MODBAR TECHNICAL BULLETIN
#29
Pour-over sleeve update

We would like to inform you about a recent modification of the holders and sleeves of the pour-over tap.

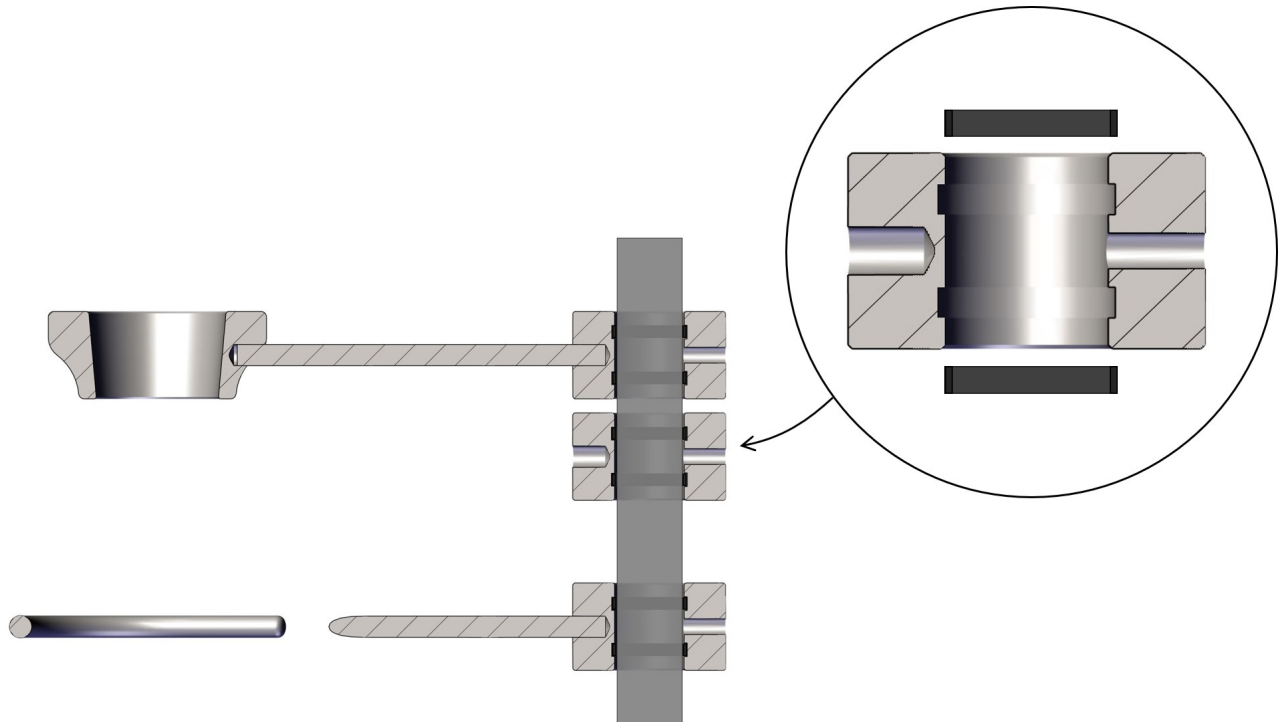
To prevent the three sleeves from scratching the chromed rod, they have been modified with added grooves. Each groove houses a plastic ring which has a slightly smaller inner diameter than the sleeve, so that the metal can't touch the rod.
This modification takes effect from serial number MB002121.

The old version of these three components is no longer available as a spare part and their part numbers are updated as follows:

A-0049-01 is substituted with 1103.

A-0062-01 is substituted with 1104.

M-0089-02 is substituted with 1105.

Each sleeve is supplied with its plastic rings, which can also be ordered separately with code F.1.147.
